# Cyclists Touring Club right to ride network

## Royston Cycle Network

# Royston cycle network plans

## Feedback from local CTC members

**CYCLE LANE PROTECTED BY  
TRAFFIC ISLANDS**

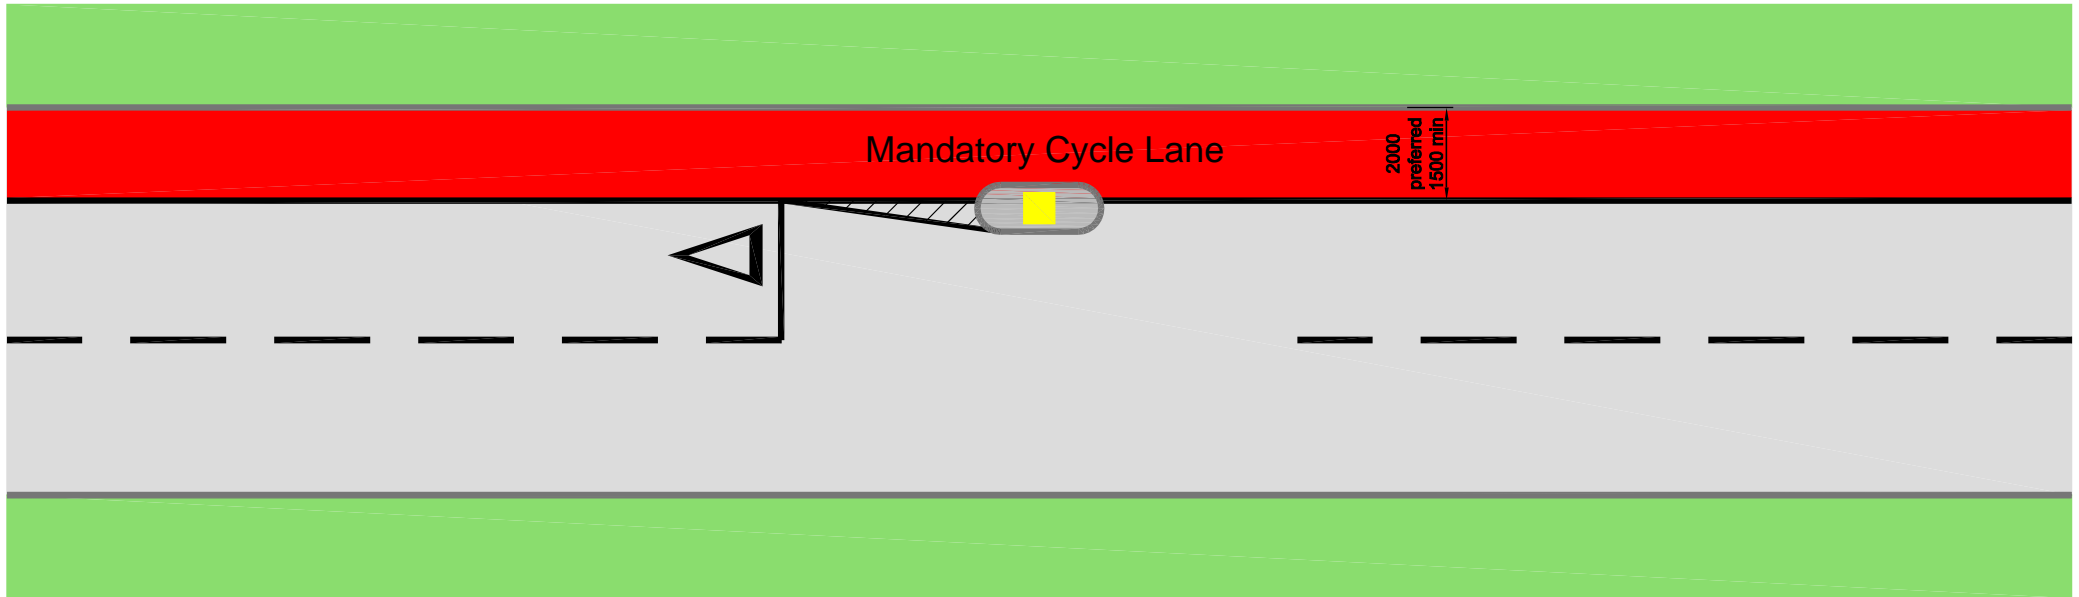
A number of design guides make reference to cycle lanes with less than the recommended (2.0m) and absolute minimum (1.5m) widths. In all cases it is made clear that sub-standard lane widths are **NOT** for general use, but only for use where:

1. There is insufficient physical width to accommodate the recommended lane width.
2. There is a clear advantage to **CYCLISTS** in having a lane, in spite of its reduced width.

The only situations where this is likely to apply are where cyclists need to pass stationary or queuing traffic, for example approach lanes to Advanced Stop Lines or bypass lanes to traffic calming features. Sub standard width lanes should not be used where the motor traffic is passing moving cyclists.

It is not acceptable to provide narrow cycle lanes in order to give motor traffic more room or greater priority. As made clear in the [Lancashire Cycling Design Standard](#), narrow cycle lanes increase the level of hazard and intimidation to which cyclists are exposed, and are almost always worse than providing no lane at all.

In all cases it is better to provide a **WIDE ADVISORY** lane (which motor traffic can legally encroach into, providing it is safe to do so) rather than a narrow mandatory lane (from which motor traffic is banned, although in practice enforcement is rare).
